**TOWN OF OCEAN RIDGE
PLANNING & ZONING REGULAR MEETING
AGENDA**

**October 15, 2024 at 9:00 AM
Town Hall - Meeting Chambers**

To: Planning & Zoning Board Members
From: Corey O’Gorman, Town Planner
Meeting Date: October 16, 2024
Subject: 6726 N Ocean Blvd – Development Plan Review

PLAN REVIEW REPORT
6726 North Ocean Blvd.
August 14, 2024 / REV Sept 30, 2024

Proposed South Elevation

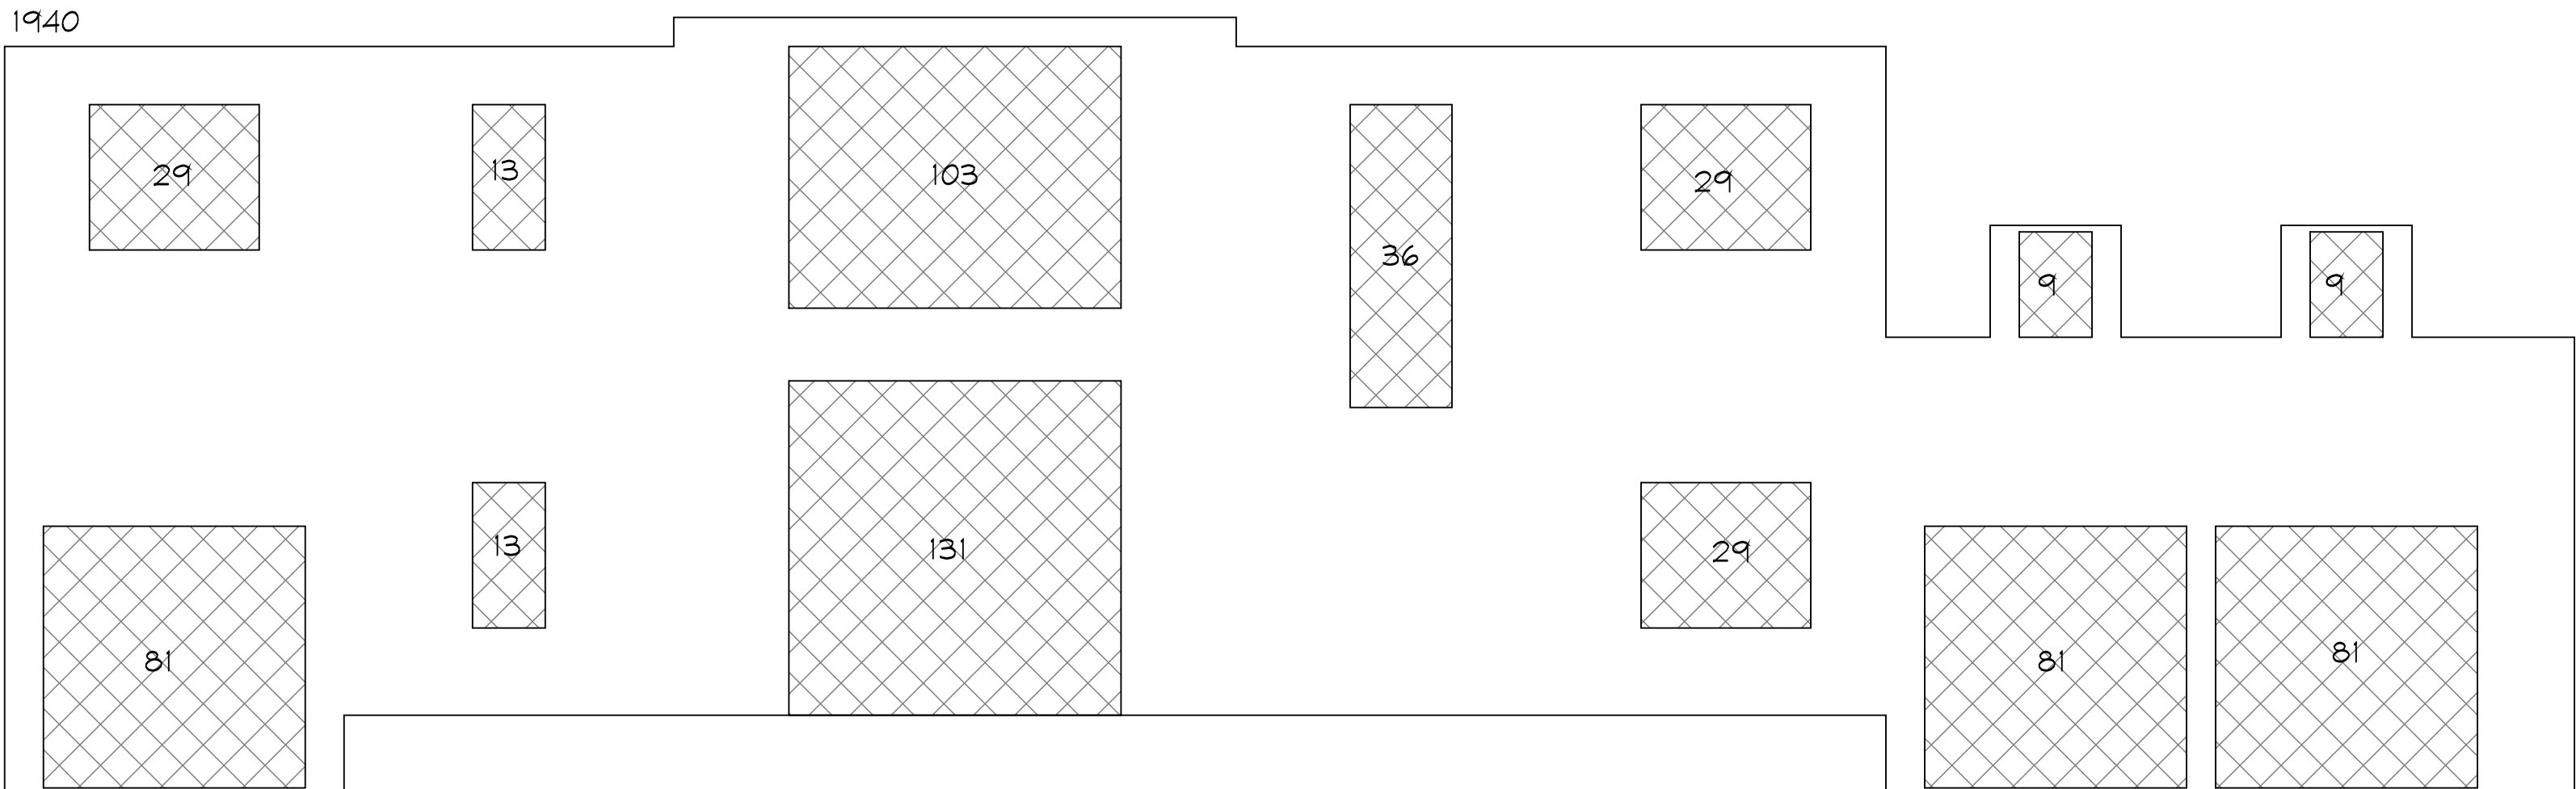
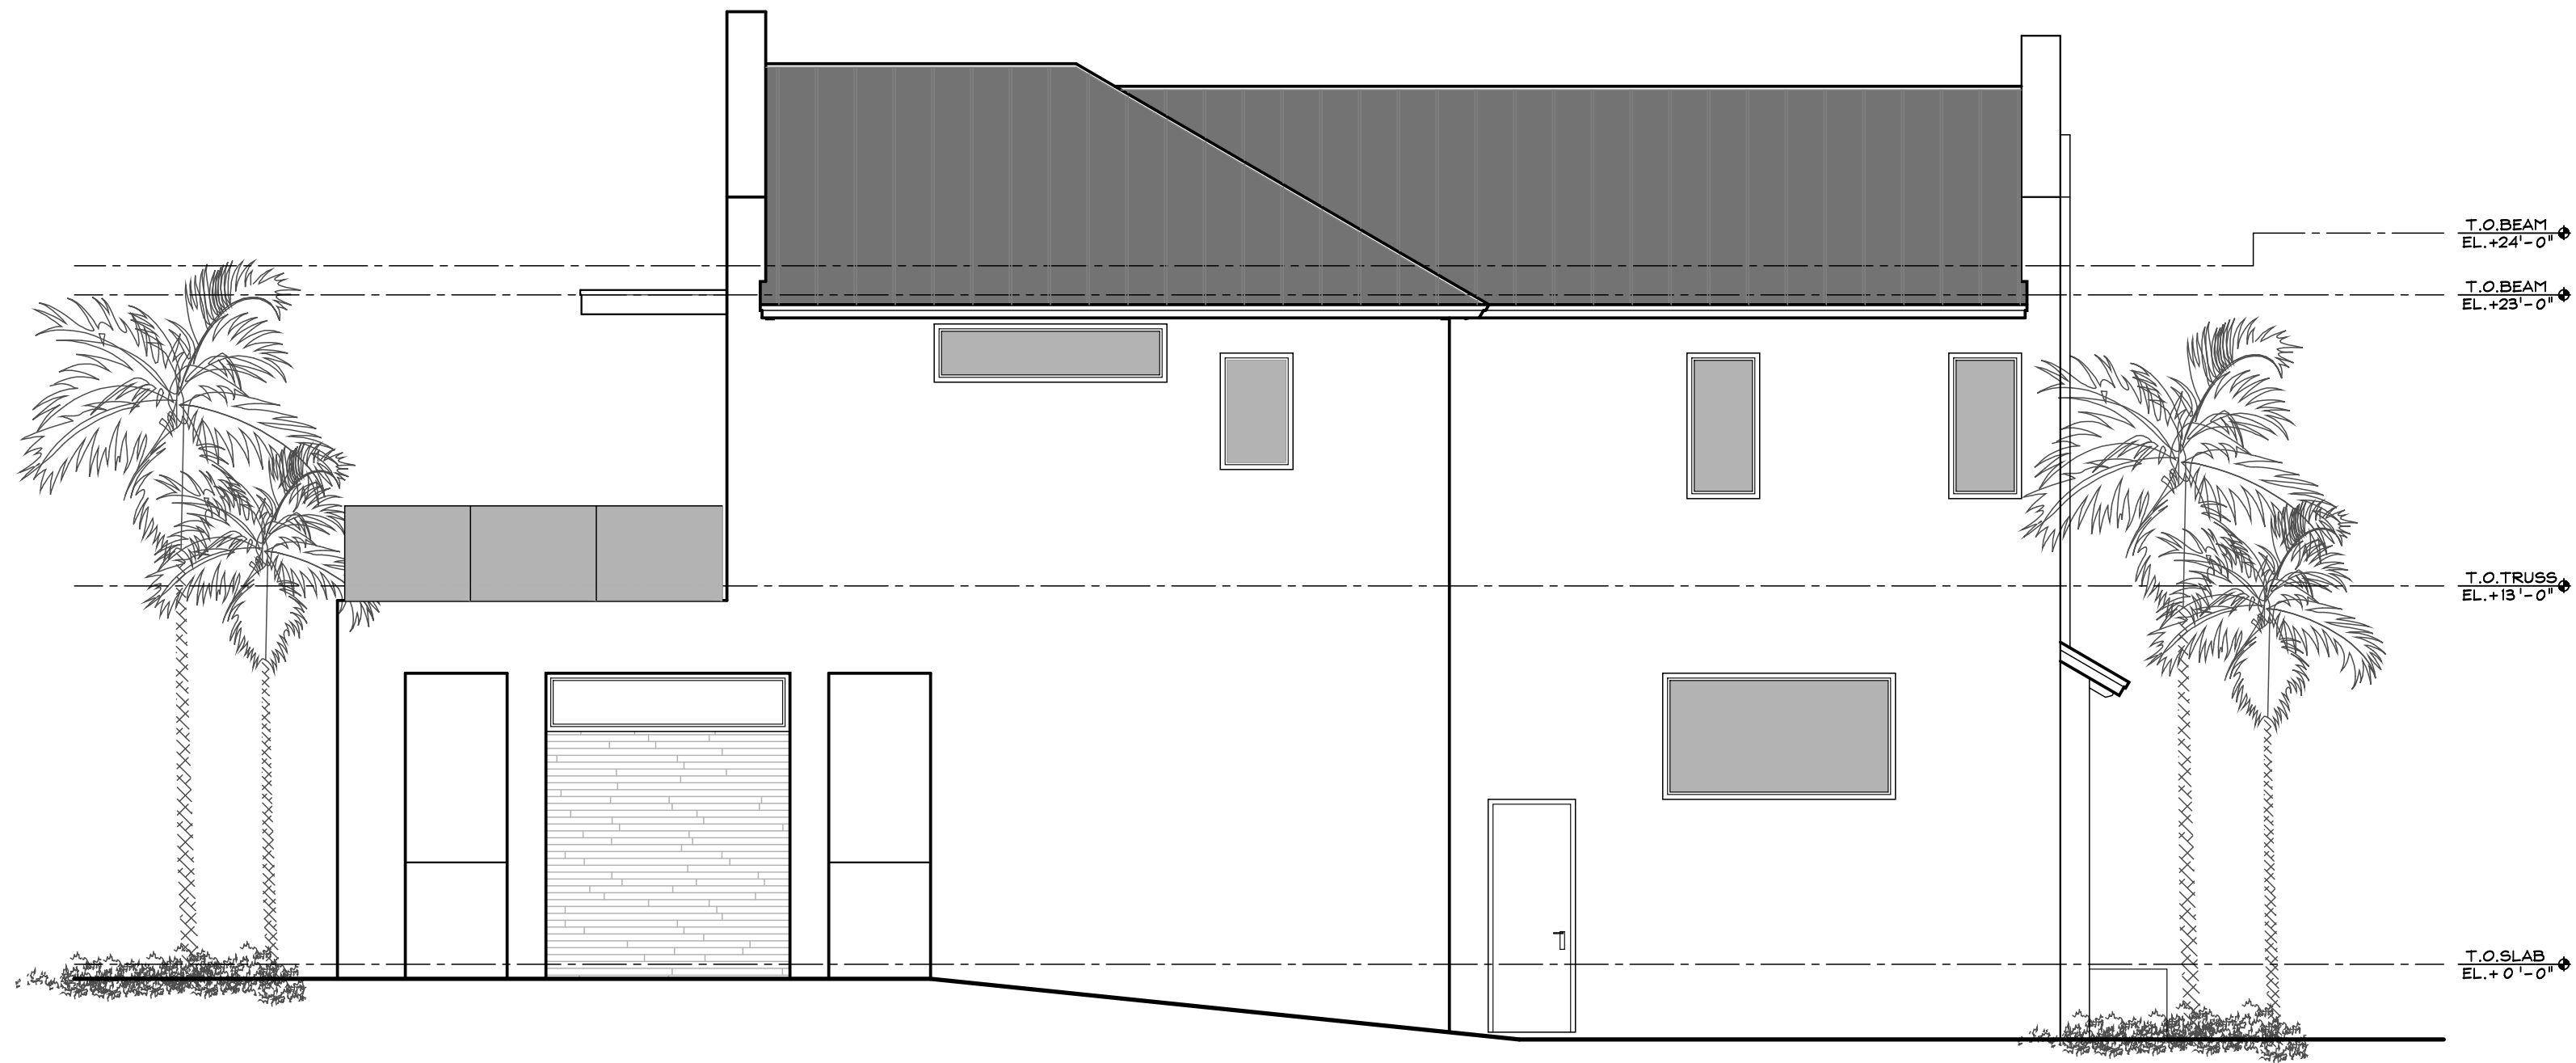
~~Section 64-1(e)(2) — Background: This Code section specifies the requirement for “substantial articulation” on all facades of the home, and the south elevation on sheet P-5 does not appear to comply with this requirement.~~

P-2

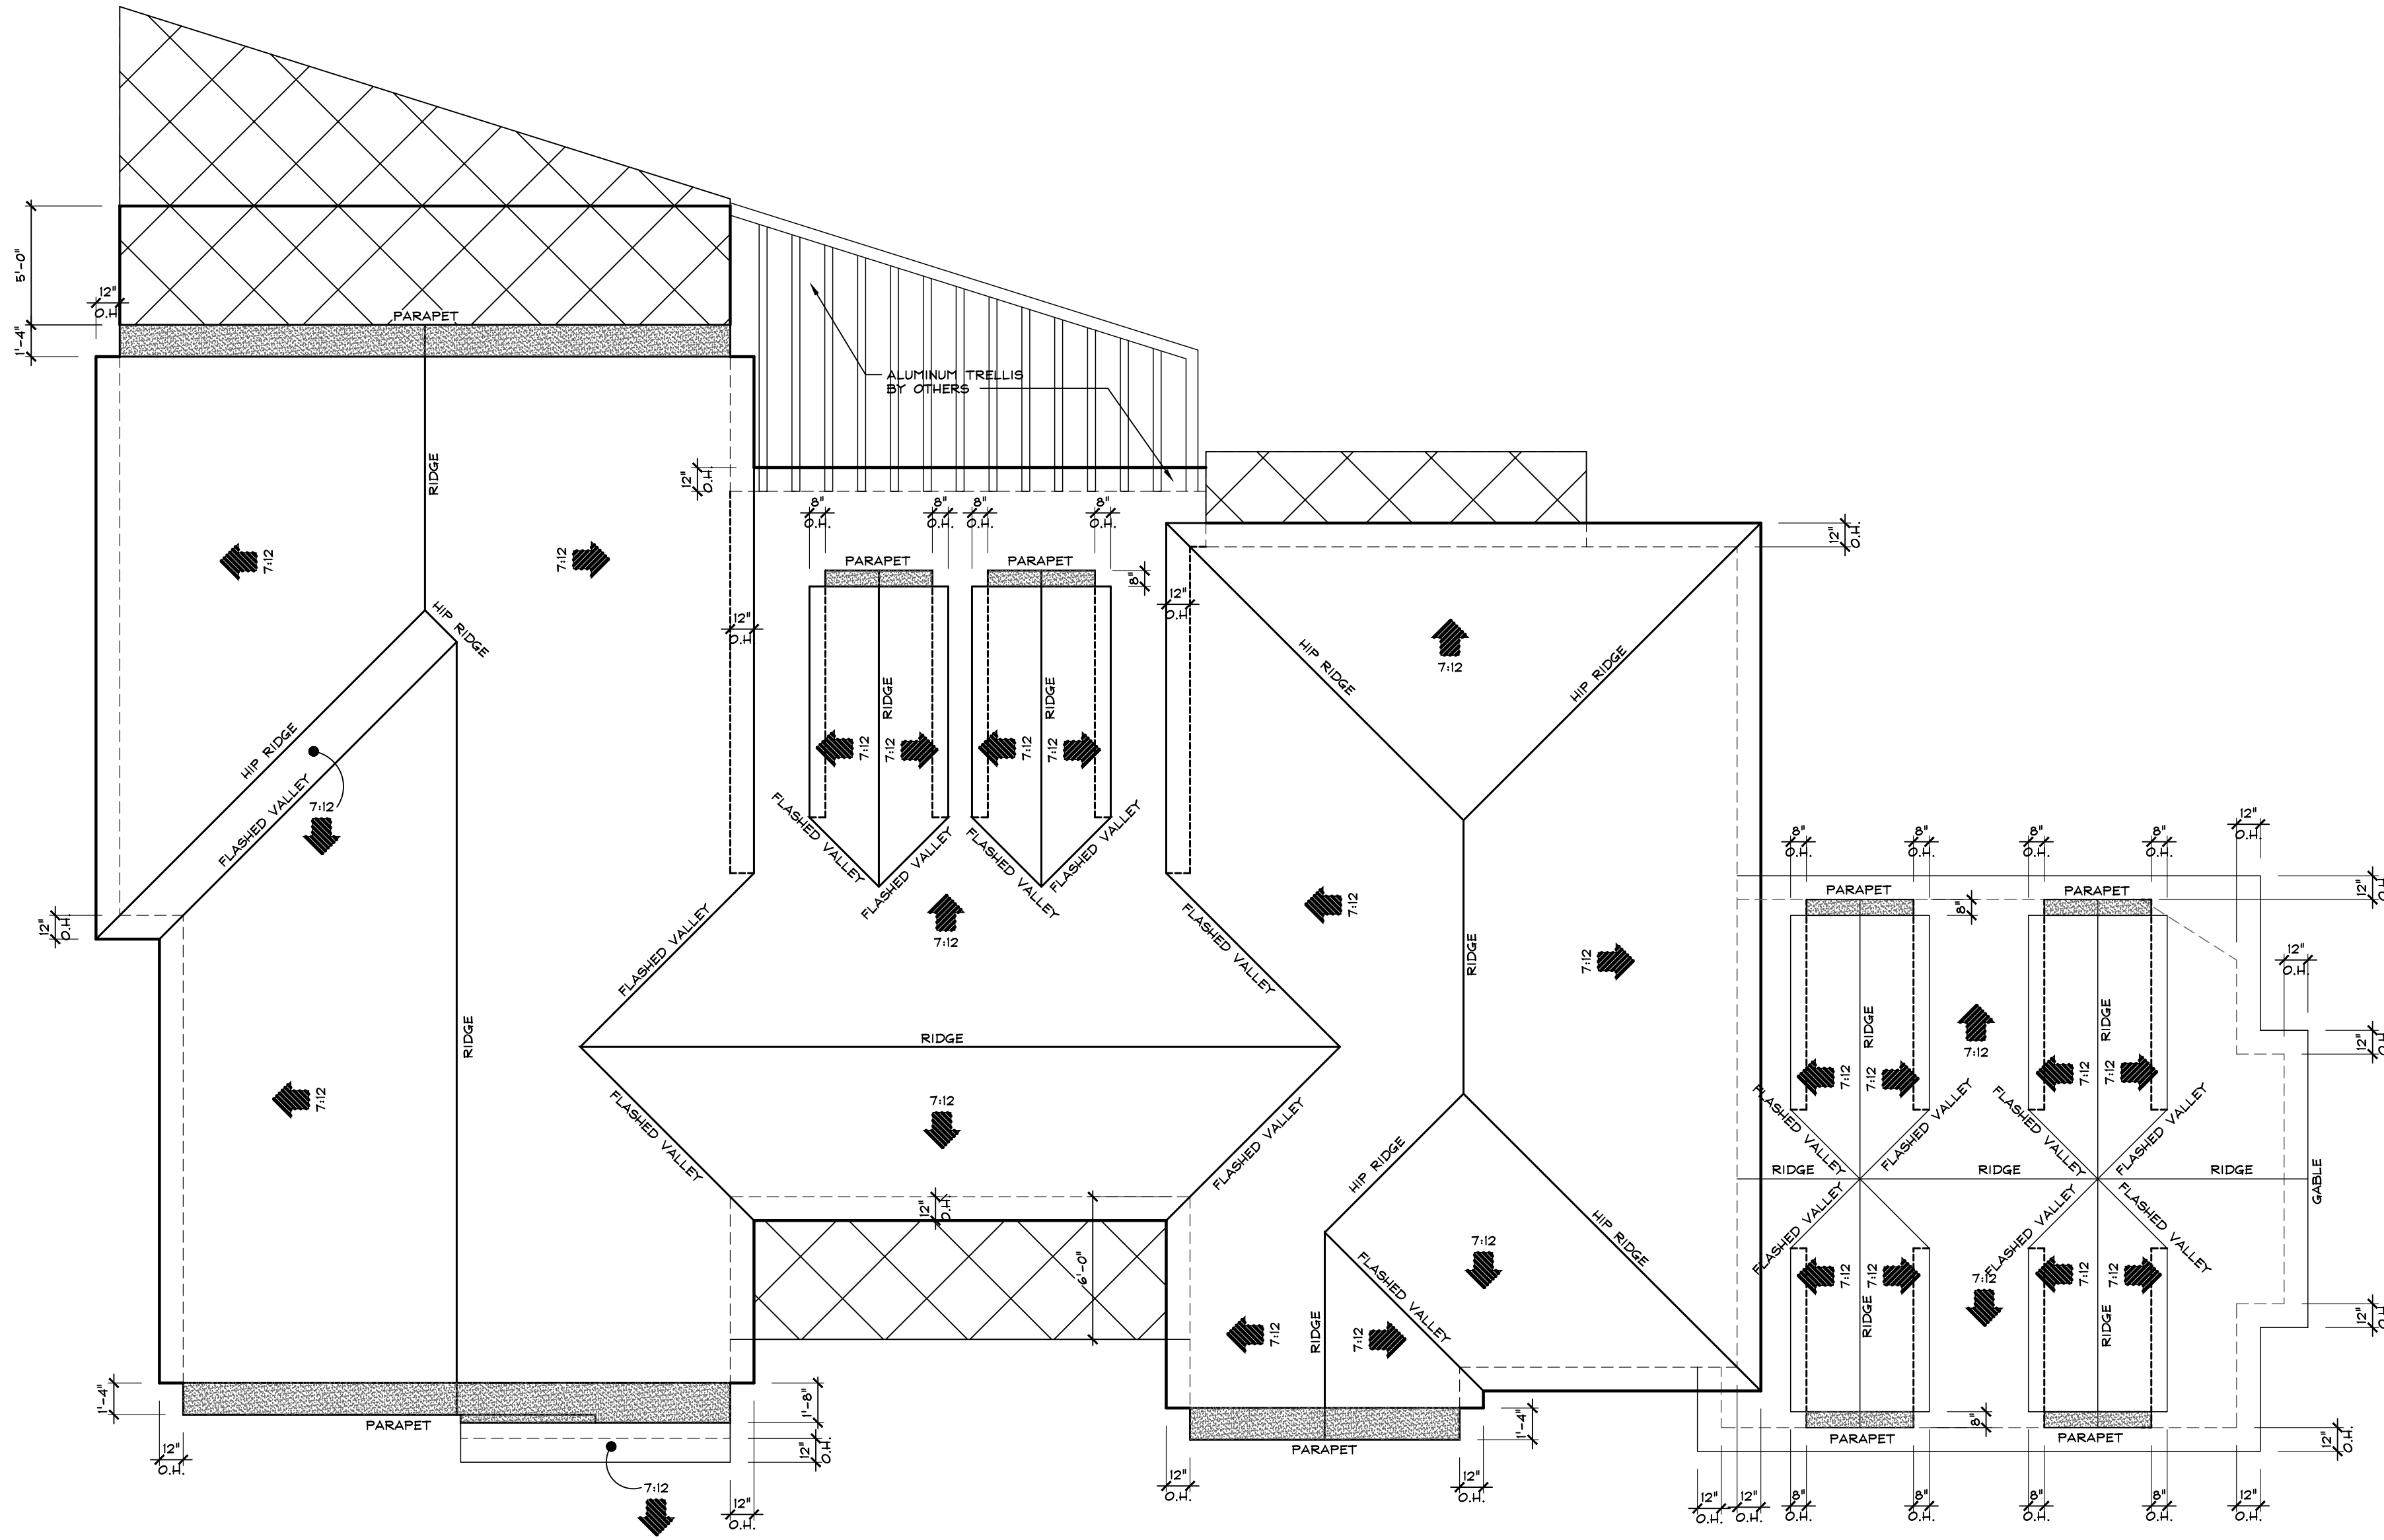
SP-1 shows "Edge of Balcony Above" which illustrates a balcony encroachment and while sheet P-2 shows a balcony encroachment, it also appears to show the bathroom in Guest Suite #2 also encroaching into the side setback.
